from Hucheng Chen:

From Dan Edmunds:

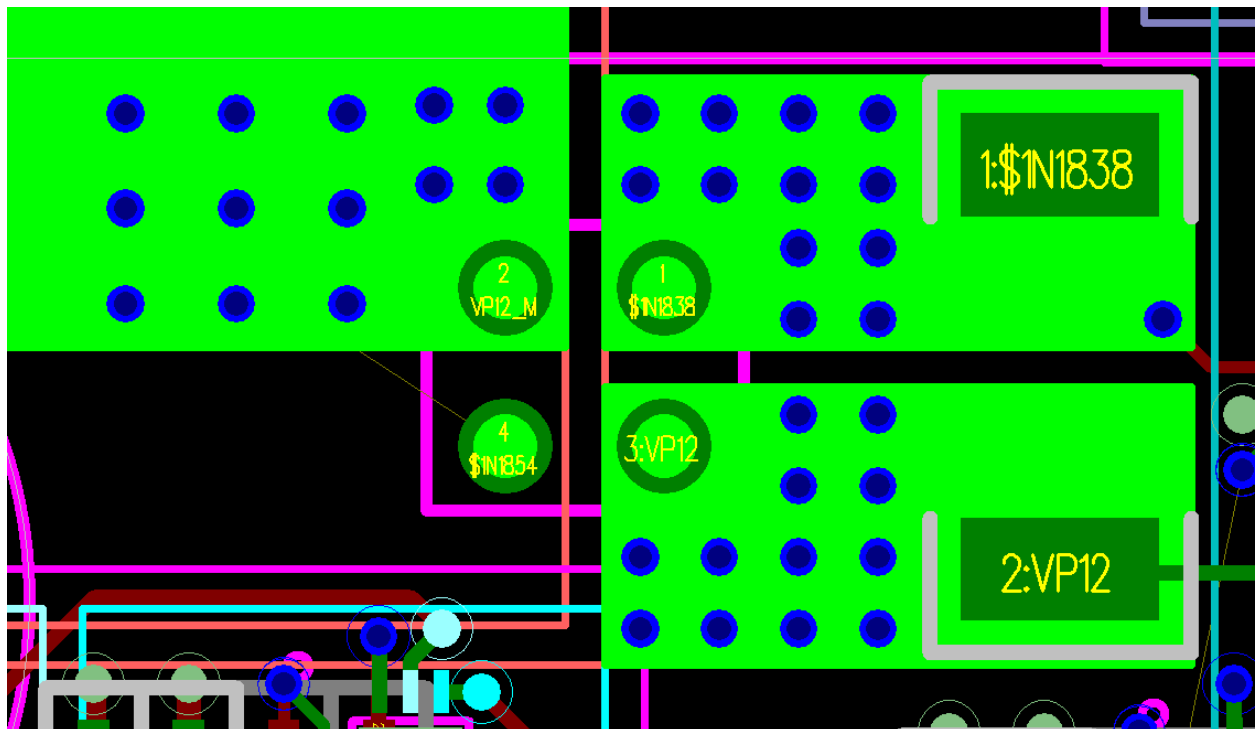
2. Connector J5 is in the current path, please make sure the pins of J5 can support up to 33A.

The jumper is certainly not rated at 33 A. We have a solution which uses multiple jumpers to get the necessary current rating. The layout has the solution we will use on the boards, as soon as we know that the 12Volt is correct when isolated from the rest of the board. A .gif blowup of the layout is below.
